ITEM FOR ENVIRONMENTAL COMMISSION AGENDA

NAME & NUMBER OF PROJECT: SP-2018-0567C Zully's B&B

REQUEST: Variance request is as follows:
Request to vary from LDC 25-8-261 to allow development within a
Critical Water Quality Zone

STAFF RECOMMENDATION: Staff does not recommend this variance, having determined that the
findings of fact have not been met.

ZULLY'S BED & BATH
8104 POSTEN LN.
PROPOSED SITE PLAN

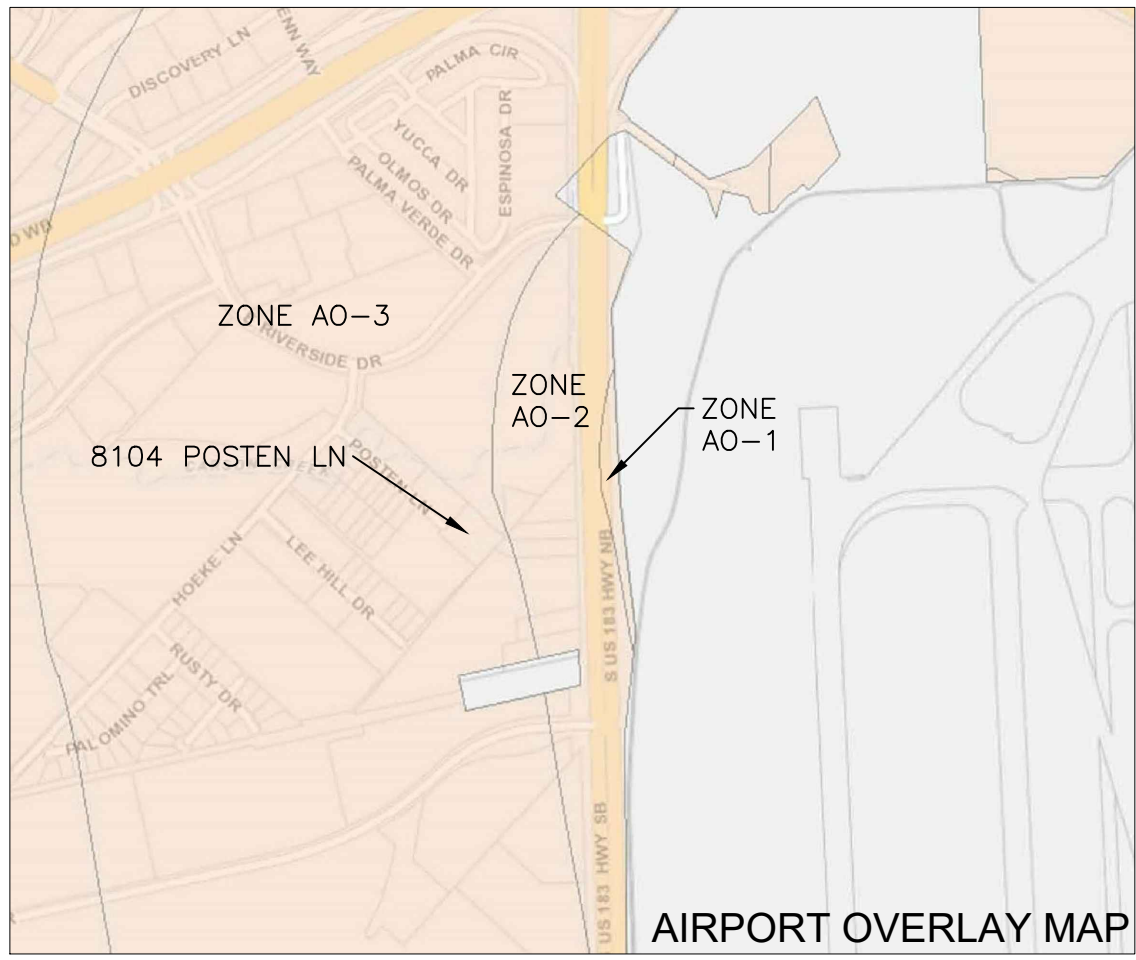
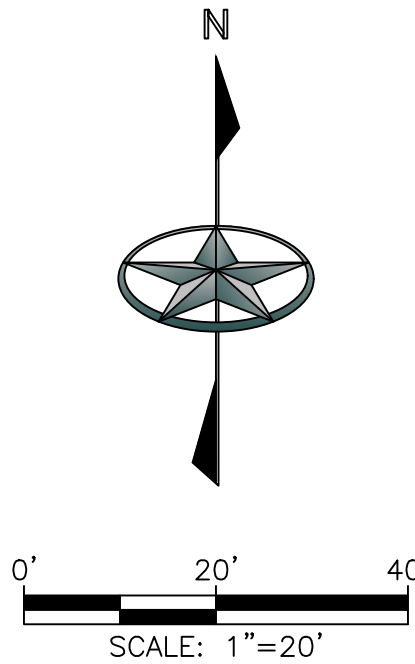
No The site has a large portion of developable uplands that will allow for the proposed development. Additionally, the applicant was encouraged to follow guidance for the Redevelopment Exception in a Suburban Watershed (LDC 25-8-25), but elected to not propose development under those regulations.

No The site has a large portion of developable uplands that will allow for the proposed development without adverse impacts to the critical water quality zone, however, the design decision made by the applicant proposes development that is not allowed in a critical water quality zone.

No The proposed development within the critical water quality zone is not allowed, and as proposed, increases the developed area footprint within the critical water quality zone where there is no existing development.

No The proposed development within the critical water quality zone will increase the developed area footprint within the critical water quality zone where there is no existing development, thereby removing pervious area and existing vegetation of natural character associated with a critical water quality zone.

No The proposed development within the critical water quality zone is not allowed, and as proposed, increases the developed area footprint within the critical water quality zone where there is no existing development.

No The site has a large portion of developable uplands that will allow for the proposed development without adverse impacts to the critical water quality zone.

No The proposed development within the critical water quality zone is not allowed, and as proposed, increases the developed area footprint within the critical water quality zone where there is no existing development.
